Delegated Application Report**Target Date:** 11/11/2022 (extended)**Address:** Green Park Station**Application No:** 220532/NMA

Proposal: Non-Material Amendment to Permitted Application 141944 to replace footway with landscaping northern end of interchange, increase of cycling parking with shelters, replacement of kiss and ride spaces with 5 short stay spaces, removal of cycle hire, reduction of footway, increase of surface level car park, removal of MSCP, new footpaths

Originally Approved 141944**Amended under 171305****Proposed under 220532**

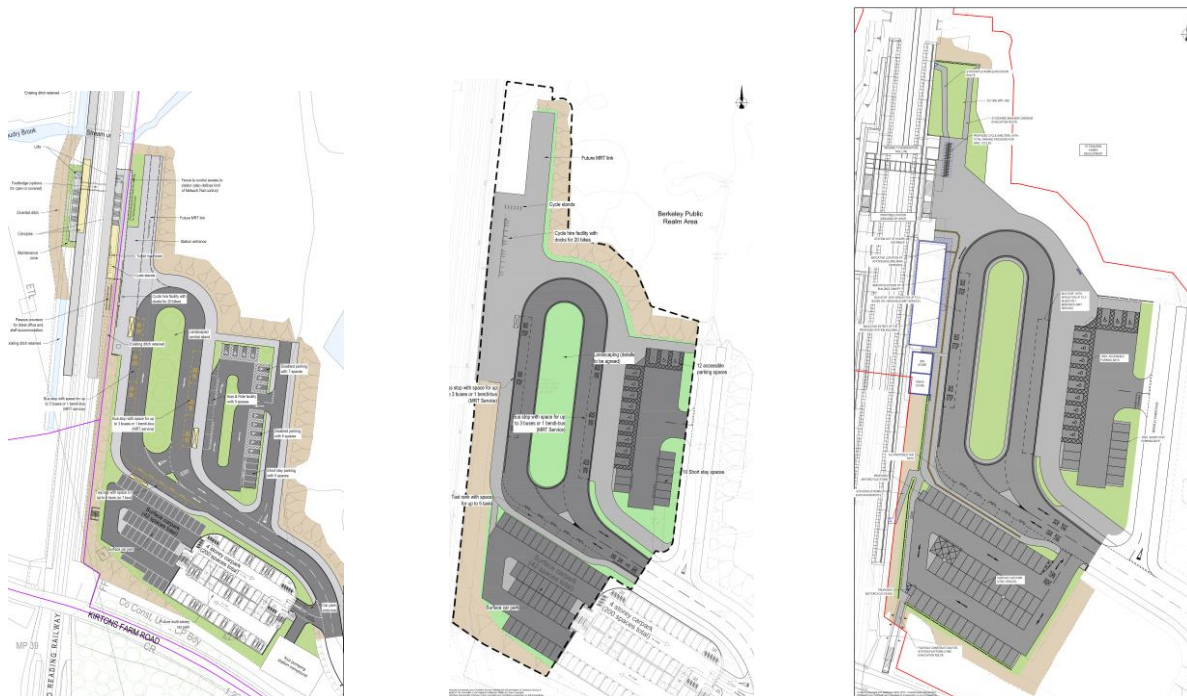
The proposed changes relate to a number of elements within the Interchange for Green Park Station as originally approved under 141944 and which was reconfigured with the following amendments under 171305:

- Swapping of the kiss and ride spaces with 9 no. of the 12 no. accessible spaces, so that the latter move slightly closer to the station.
- Number of short stay spaces to total 10. No (i.e. same as original five short stay and five kiss and ride)
- Total surface car parking spaces and accessible spaces to remain as the consented scheme, i.e. 42 no. and 12 no. respectively.
- Retention of 5 no. taxi spaces.
- Reconfigured landscaping areas.

The proposed further amendments under this 220532/NMA are as follows:

- Replace footway with landscaping to the northern end of the interchange.
- Increase cycle parking to 24 cycles, relocate cycle stands include shelters over.
- Replace the kiss and ride spaces with 5 short stay spaces.
- Remove the cycle hire.
- Reduce the footway to the western edge of the Interchange.
- Remove the multi-storey car park, introduce access to the surface level car park from a priority junction onto Flagstaff Road, and increase the no. of spaces to 57.
- Introduce new footpaths to north and south ends of eastern platform; to the west of the surface level car park.

- The submitted plan illustrates a potential location of a cycle store however it is my understanding that the cycle parking has previously been agreed and as such this should specify the full details of this cycle store. It is also my understanding that this has already been erected on site. The increases in cycle parking as a replacement of the cycle hire cycle spaces is however accepted.

- The scheme has been redesigned to provide just the two footways to the north as a MRT link would not be required as yet and this is accepted however, further details will be required as to where these path lead so it can be determined that they are sufficient. The drawing also illustrates some hatching where the footway commences and as such it would need to be clarified what this is to represent.

If the hatching represents a slope down to existing levels I would question whether this is a suitable location for the path to connect to the main interchange area. The change in levels could create difficulty for those with mobility issues or that are partially sighted etc and as such be a danger. If the path is to remain as proposed then levels of the footway must be provided to ensure a safe route from the emergency access.

I would also question whether the cycle parking is appropriately located in relation to this path in ensuring a clear path / route in an emergency.

The indicative location of the cycle storage was detailed in the original submission. The NMA provides a similar level of detail as to that submitted under the original application but we are happy to provide the detailed design for the cycle storage. I have attached the specification for the bike stands and bike shelter, as well as an extract of the location of the bike storage.

Please see attached the proposed levels drawing (Finished Surface Contours - Drawing no: 36382/2011/700/02 Rev C7).

North of the station is the area with the most space for the shelters. The siting of the shelter allows for a large open public realm area outside the station, which would help to accommodate crowds waiting to enter the station during busy periods, such as when there are events at Select Car Leasing stadium. There is 1.5m clear width between the cycle shelters and the northern edge of the paved area, which is the same width as the evacuation route.

Planning Officer Note: Further to the receipt of the relevant plan to show how the footpath would connect into the St Edwards development (Phase 6A of the Green Park Village Development), Transport confirmed that the NMA was acceptable.
